An Coimisiún Pleanála- Case reference: Gas-Insulated Switchgear substation and HV cables (ABP-320094-24);

Observation Submitted By: Shane and Sinead Madden  
Observers Address: Coolpowra,Portumna,Ballinasloe,  
Co.Galway. H53KV91  
Date: June 2026

**Figure 1.3 Indicative Gas Pipelines Routes**

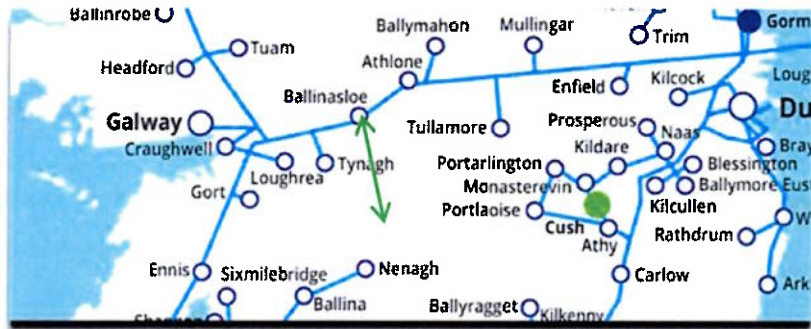
In the initial EIAR, the potential gas main routes were outlined on the drawing below<sup>1</sup>. The indicative route suggested a gas supply from the existing main in New Inn.

**The indicative route for an associated gas pipeline has been considered as part of this assessment. This will commence at New Inn, just north of the M6 Motorway and approximately 23.5 km north-west of the development site. The pipeline will be established by Gas Networks Ireland (GNI) through a separate planning application, and this will complete a full assessment of the preferred route associated full assessment.**

At the developer's request, GNI commenced a process in selecting the preferred gas main route. A public meeting was held in Kiltormor on 20/05/2025. At that public meeting, GNI explained that the preferred gas main route would now be via Ballinasloe. At that meeting, GNI confirmed that they had advanced the route selection works at the request of the developer. The developer's aim was to mitigate delays if and when planning permission was awarded.

Presently, the route selection has been advanced to a stage where GNI are discussing Terms and Conditions with local landowners about laying the main through their lands. An indicative route is offered on drawing below in green arrow. The route will be approx 25km. It's indicative as the developer has not furnished updated information.

Despite all these substantial developments, the developer's latest EIAR has not in any way shape or form informed the planner of these changes. Furthermore, the proposed route is now well enough established that a full assessment of impact can be determined.

Proposed 100mm ID watermain connection shown green below

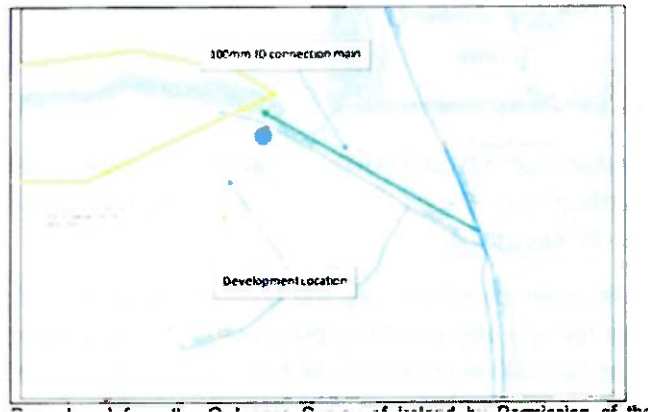
As part of the latest EIAR submission, the developer has submitted attachment D which relates to a proposed watermain connection joining an existing main on the N65 to the site. The drawing provided in attachment D is shown below.

The works associated with the watermain connection have not been included in the EIAR assessment, the AA screening report or the NIS. The omission of these works is unacceptable as it will entail the following:

- Watermain connection on the N65 resulting in extensive traffic management on the N65.
- Laying of a new 100mm watermain on the L8763 for 250m. The L8763 is built upon an Esker. The proposed watermain will require excavation of this esker. The proposed watermain pass multiple residential properties and utility services on this proposed route.
- The route of the watermain within the site is not detailed. There are no details on how the main will navigate the multiple watercourses within the site that feed to Lough Derg, River Shannon etc.
